AZUCENA STREET
30-INCH SEWER PROJECT

SAWS Job. No. 11-4518
SAWS Solicitation No. B-12-059-DD

ADDENDUM NO. 3

October 8, 2012

MAP No. 134-582,132-584 SHEET
SECT. No. 14 OF 34
DR. MDS CK. MBH JOB No. 11-4518

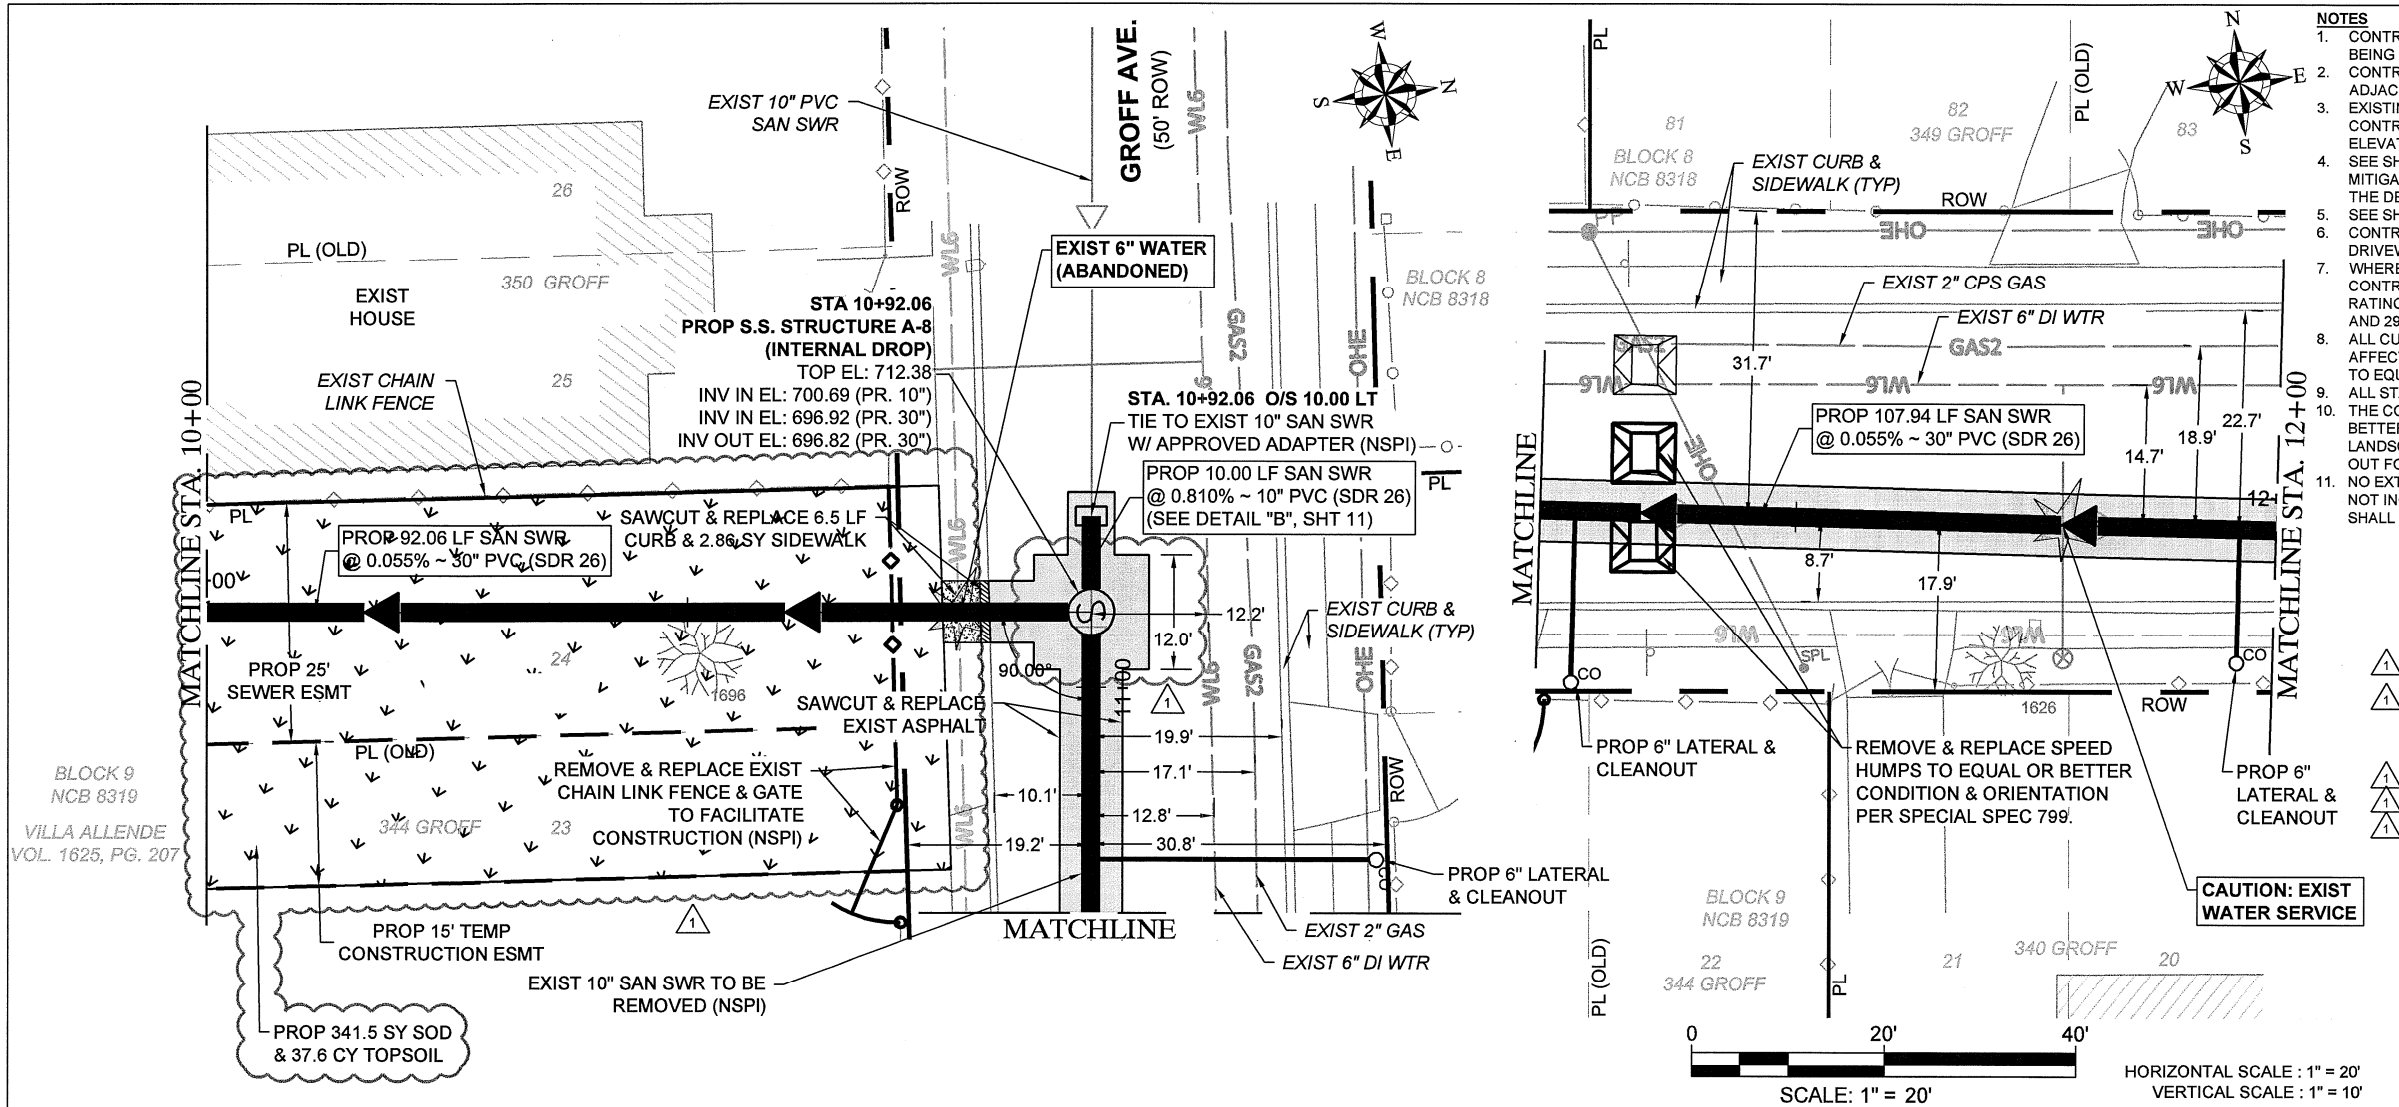
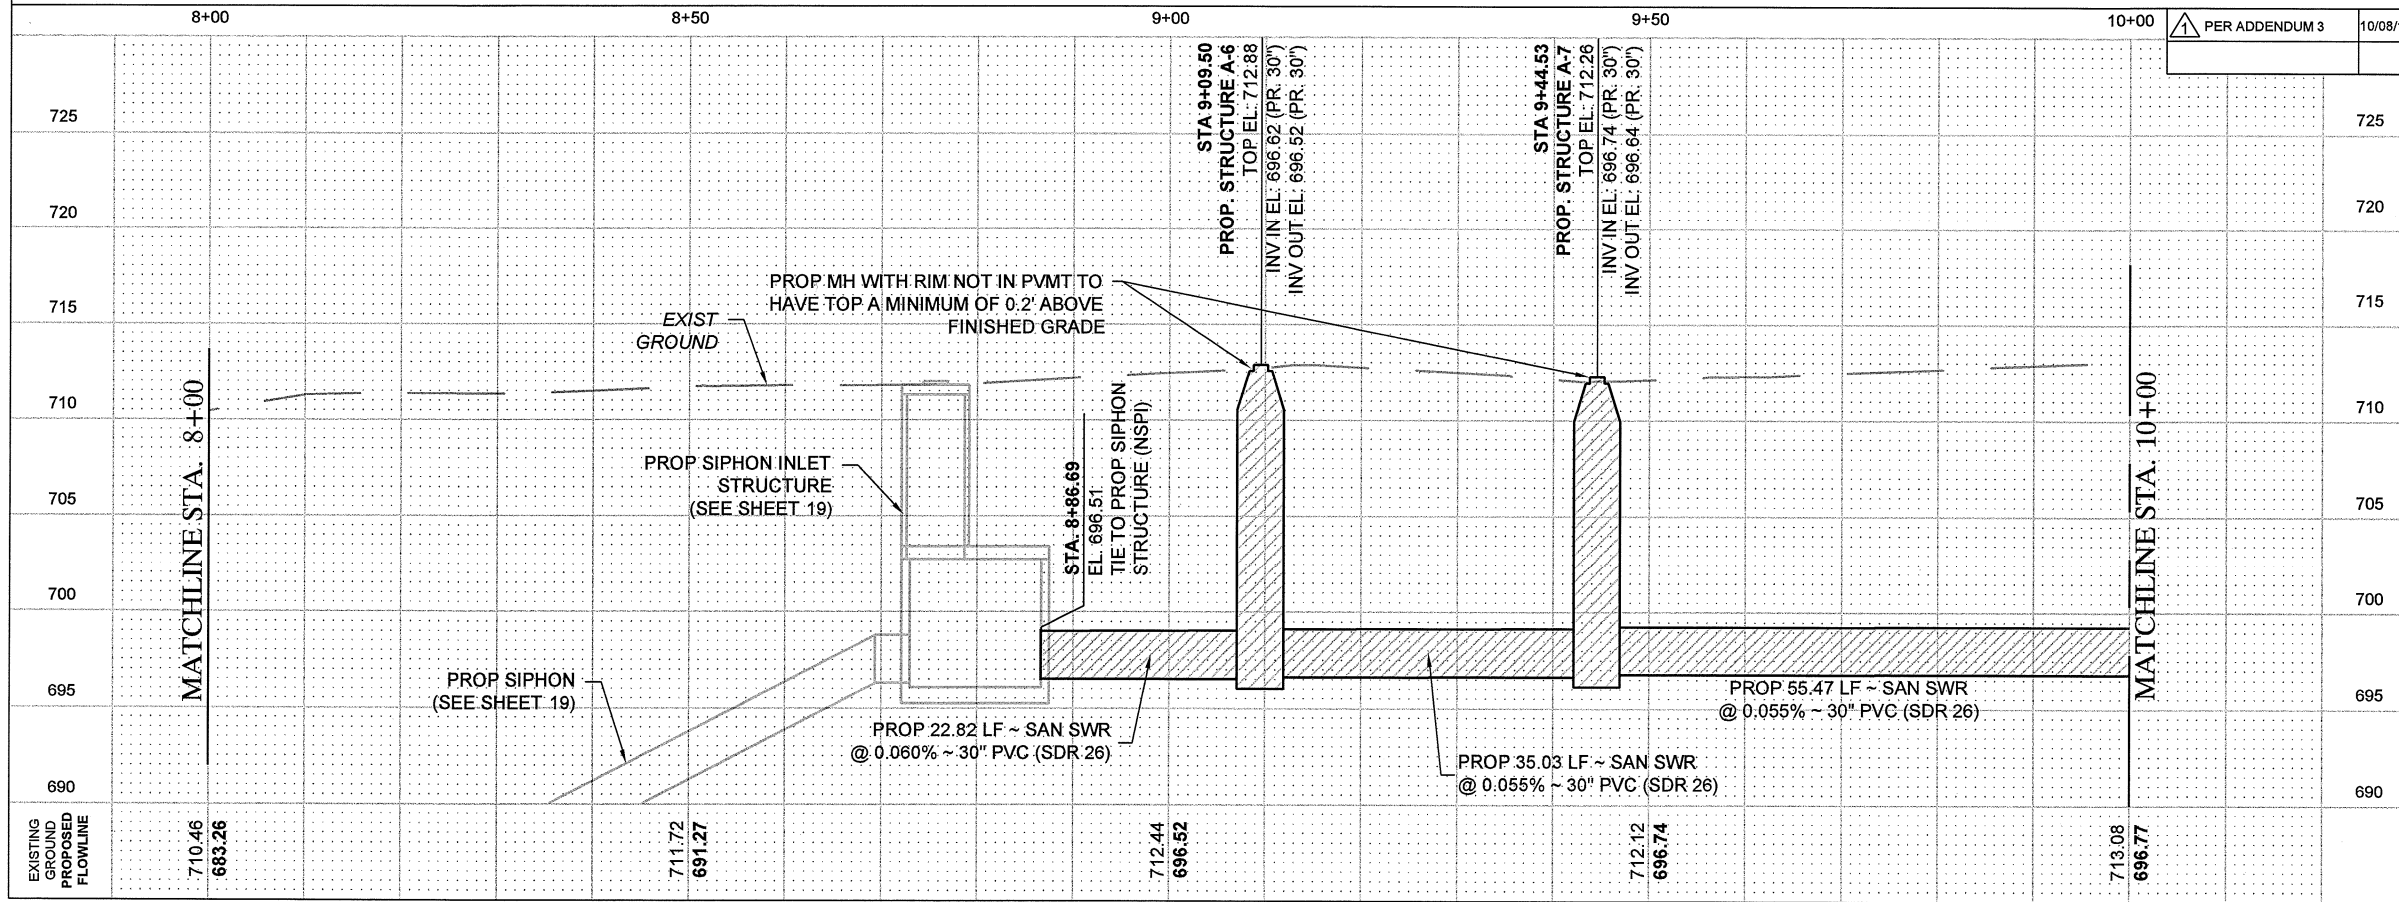
J. **Construction Plans – Sheet 14** – Remove in its entirety and replace with the revised “Sheet 14 – Line A – 30-Inch Sewer Plan & Profile – Sta. 8+00 to Sta. 10+00” attached.

SHEET **15** OF 34

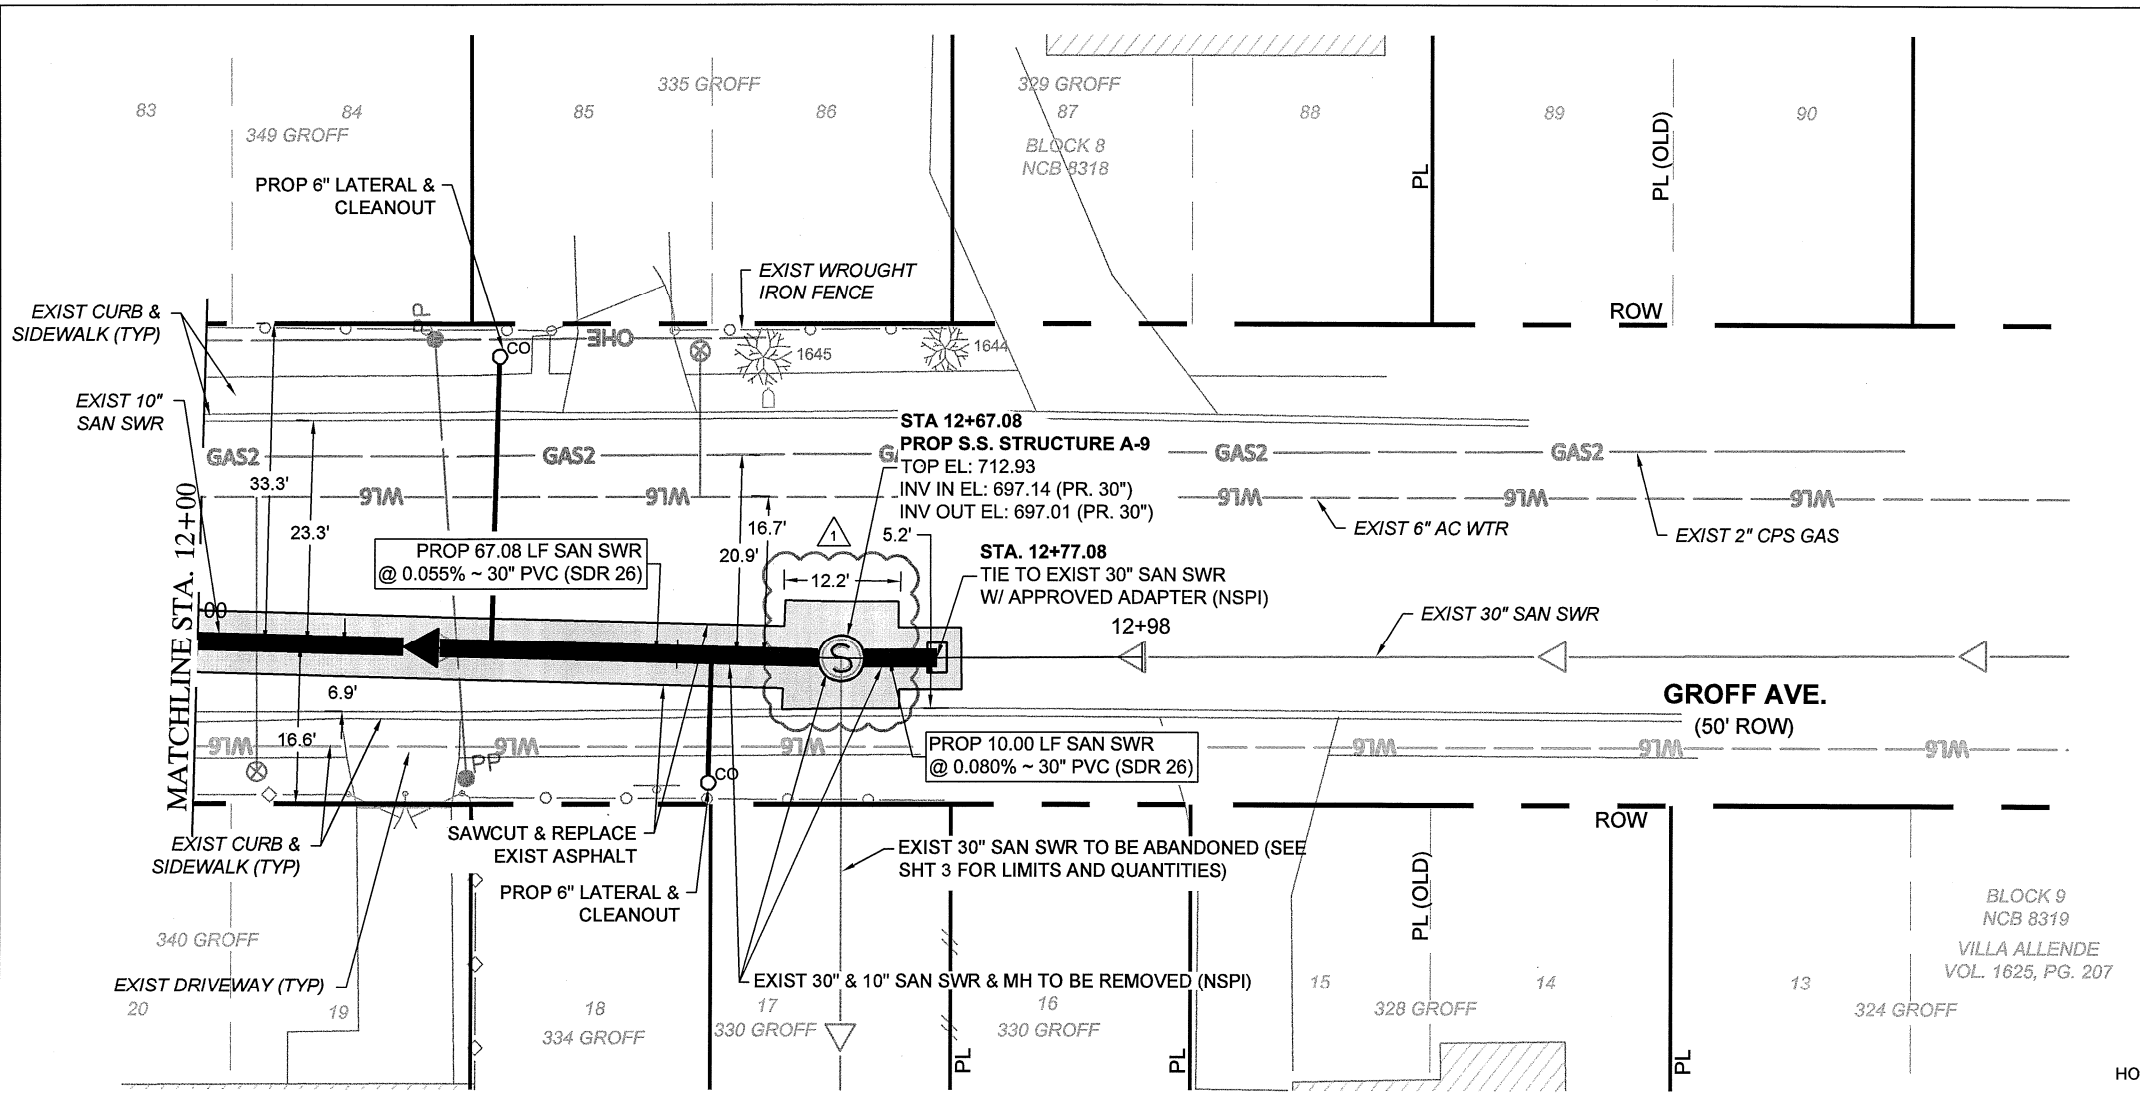
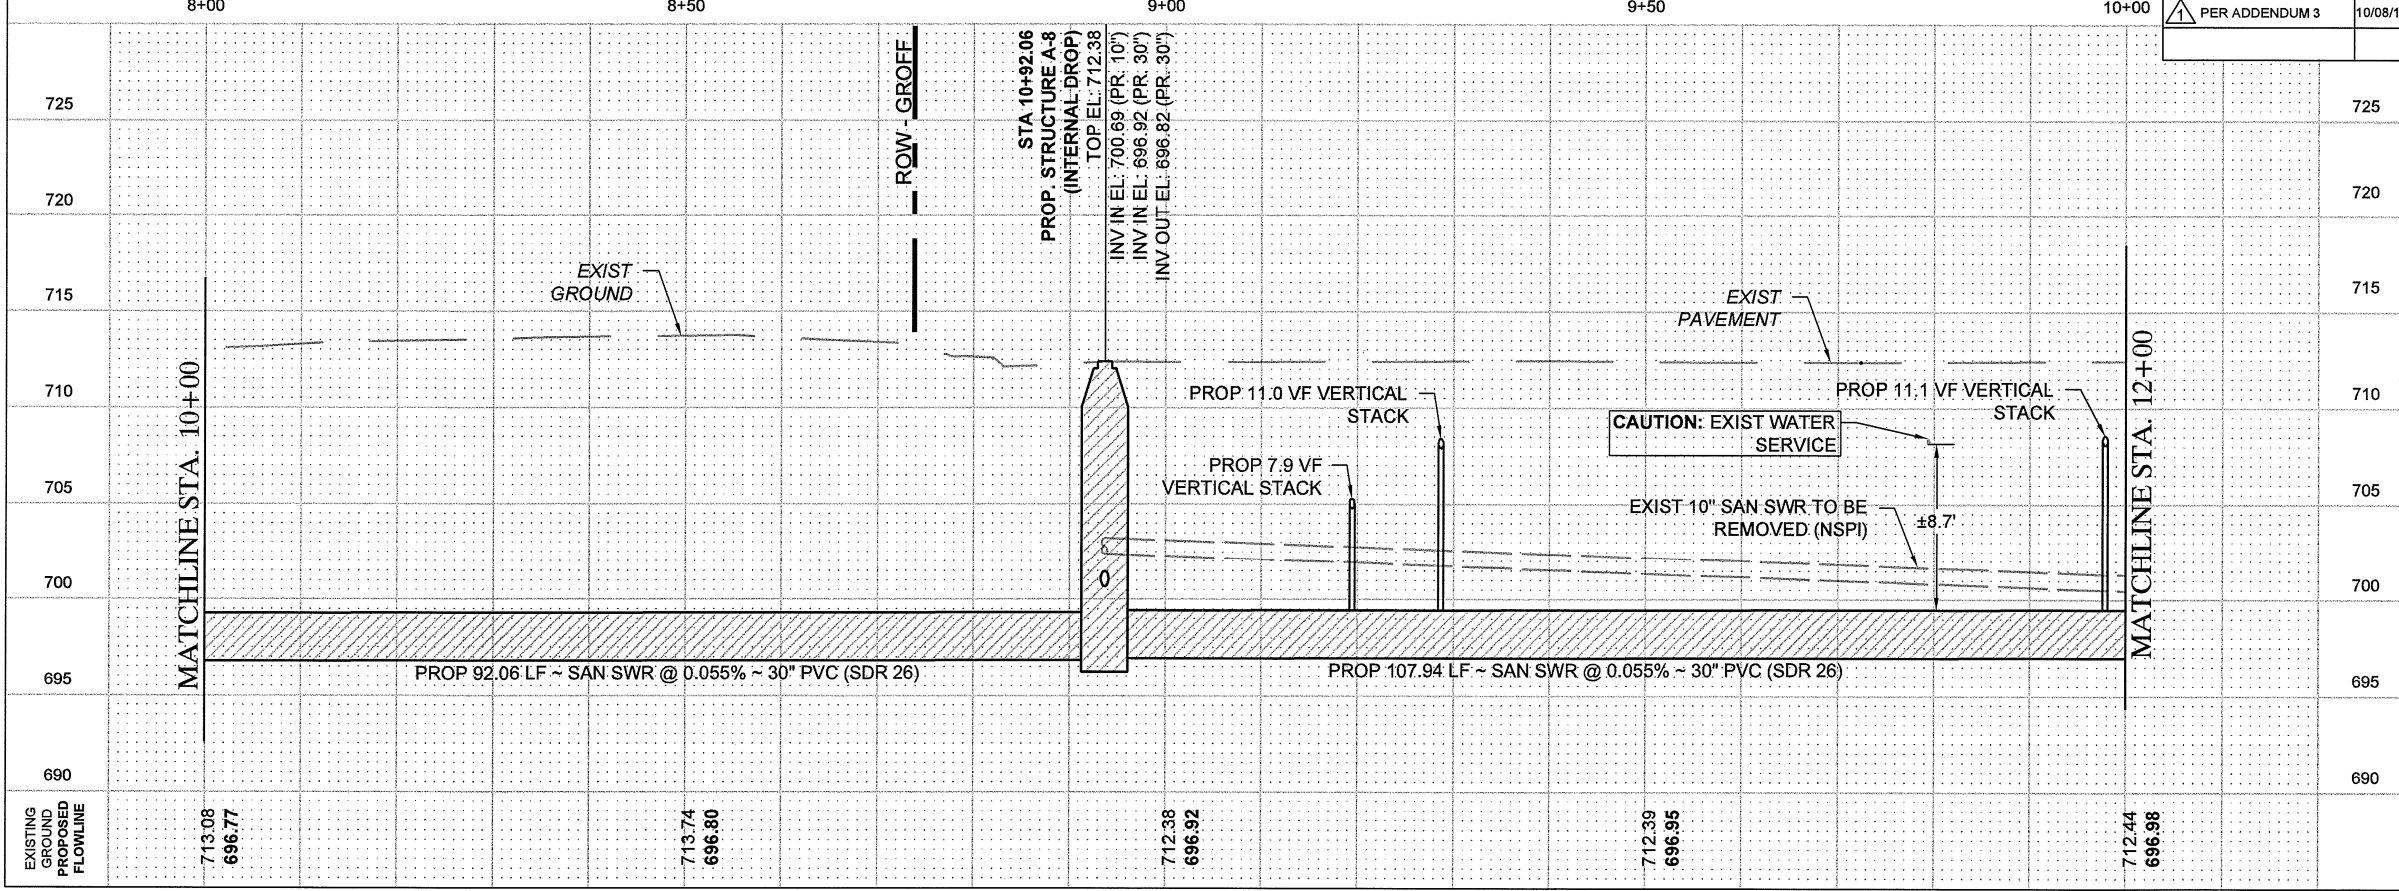
K. **Construction Plans – Sheet 15** – Remove in its entirety and replace with the revised “Sheet 15 – Line A – 30-Inch Sewer Plan & Profile – Sta. 10+00 to Sta. 12+00” attached.

MAP No. 134-582,132-584 SHEET
SECT. No. DR. MDS CK. MBH JOB No. 11-4518 16 OF 34

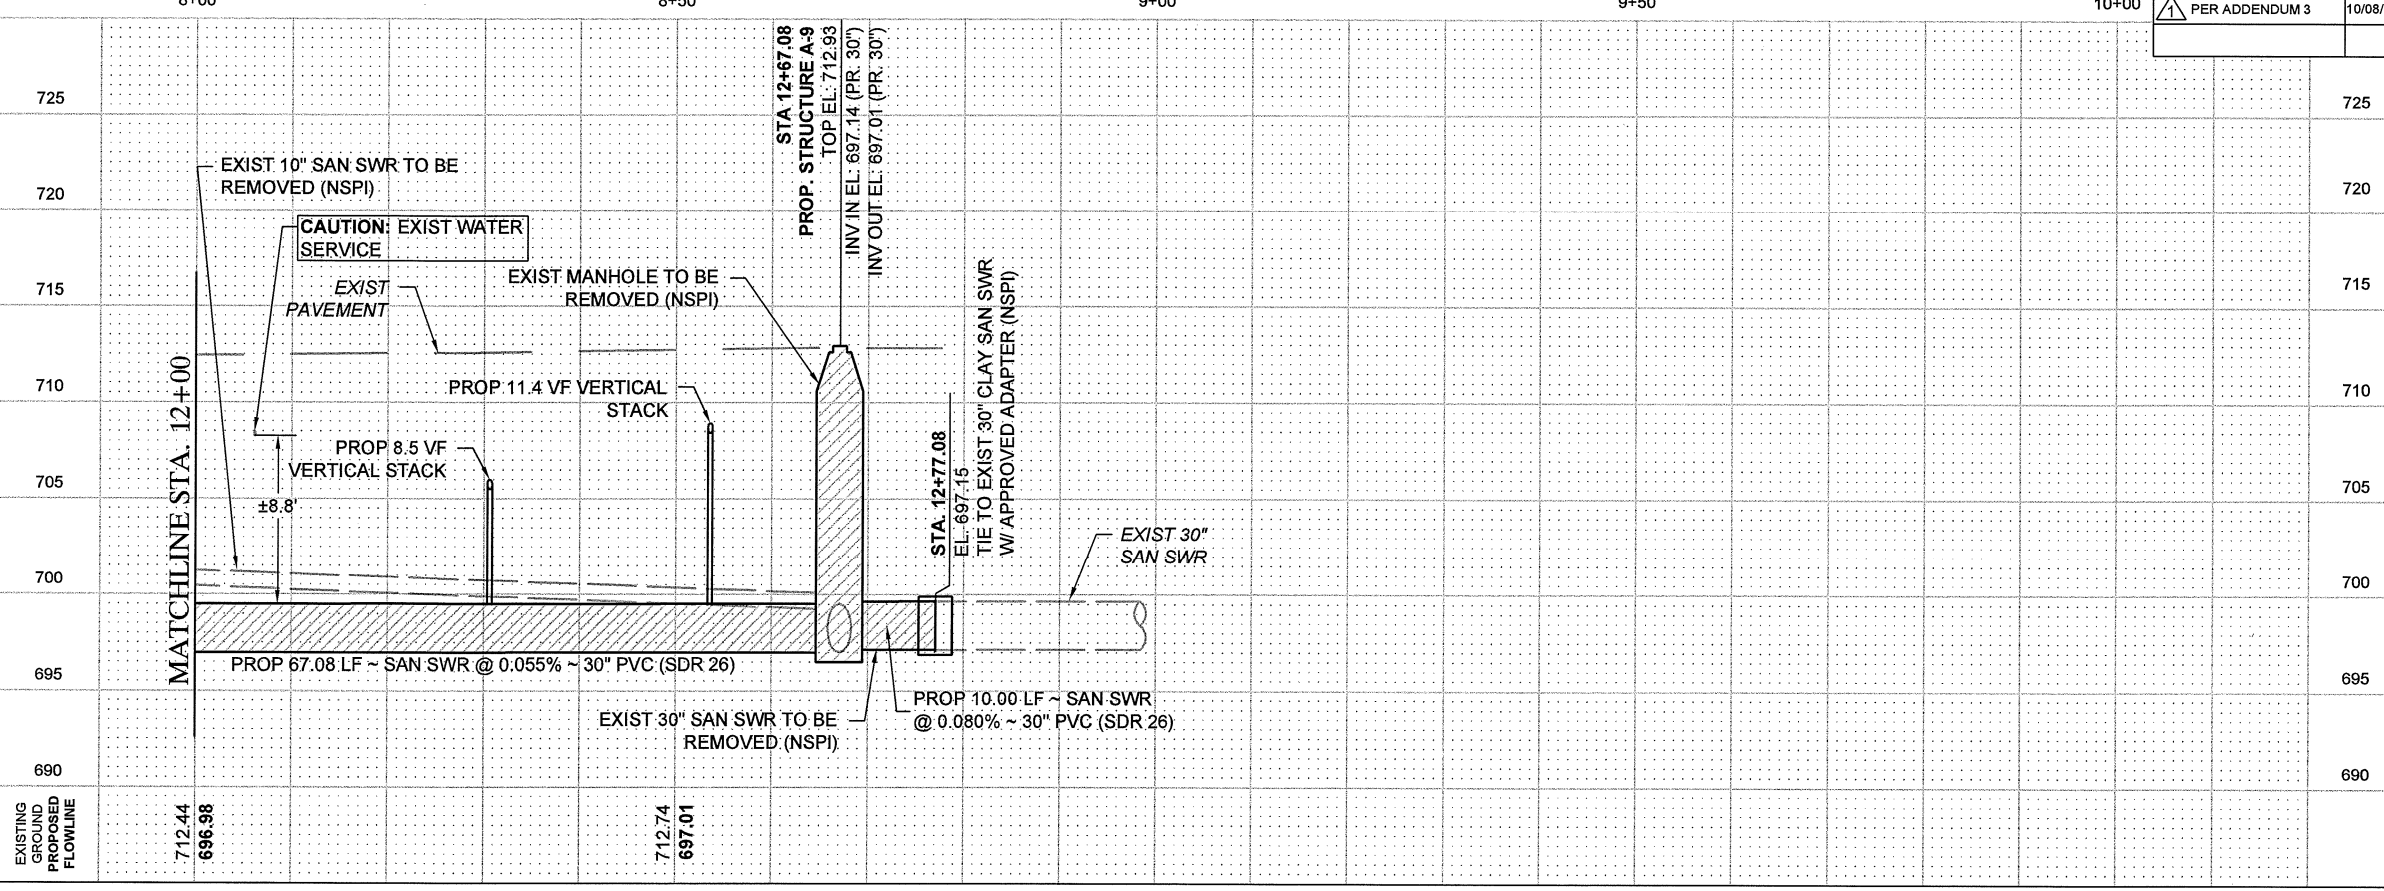
- L. **Construction Plans – Sheet 16** – Remove in its entirety and replace with the revised “Sheet 16 – Line A – 30-Inch Sewer Plan & Profile – Sta. 12+00 to End” attached.
